From: [Downes, Scott G \(DFW\)](#)
To: [Jeremiah Cromie](#)
Cc: [Torrey, Elizabeth M \(DFW\)](#); [Jeremy Johnston](#)
Subject: RE: VA-22-00001 Roeder - Notice of Application
Date: Thursday, February 17, 2022 10:51:53 AM

RE: VA-22-00001 (Roeder)

TO: All Staff
FROM: Public Works Plan Review Team
DATE: March 3, 2022
SUBJECT: VA-22-00001 Roeder

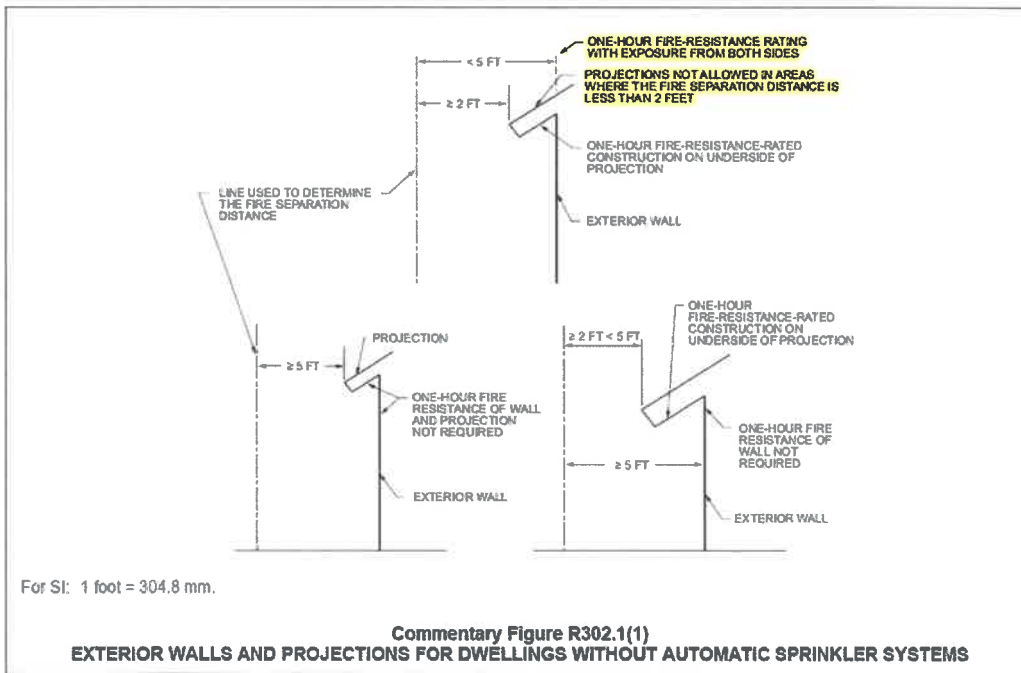
*2018 IRC Table R302.1(1) does not allow roof eaves, overhangs or any projections closer than 24 inches to a lot line.

*Exterior walls located less than five (5) feet from a lot line must be one-hour fire-resistant rated.

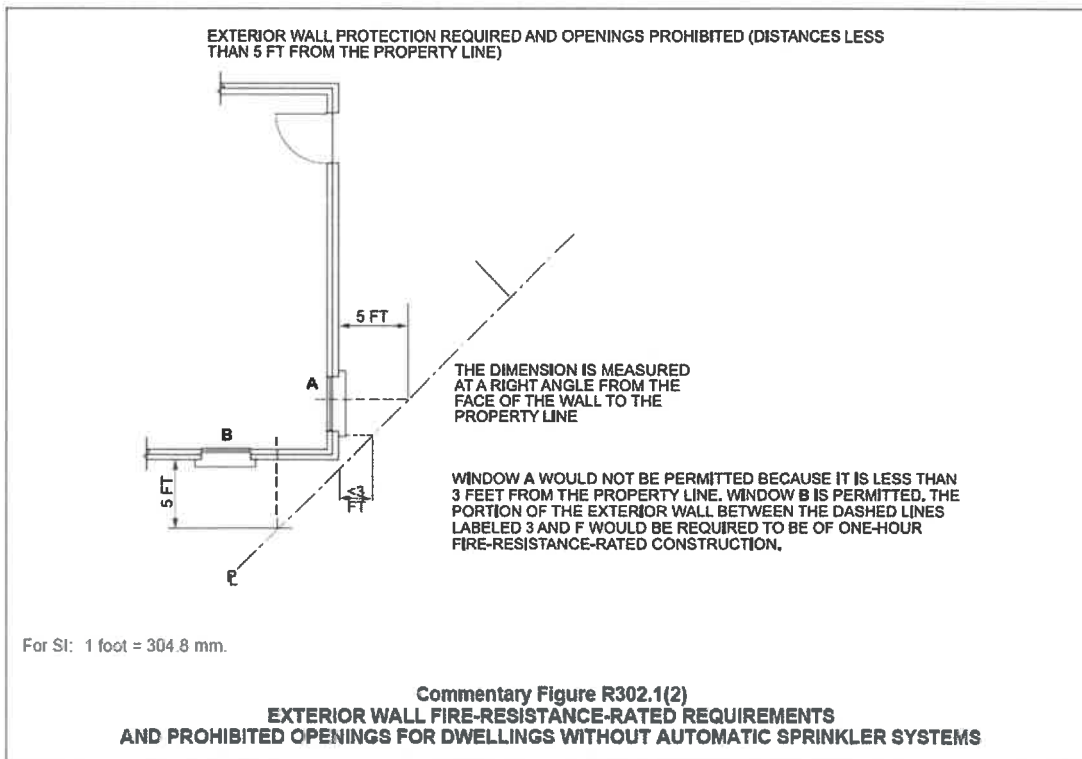
*Window and door openings in walls less than three (3) feet from a lot line are not allowed. Please see commentary figure R302.1(2) below.
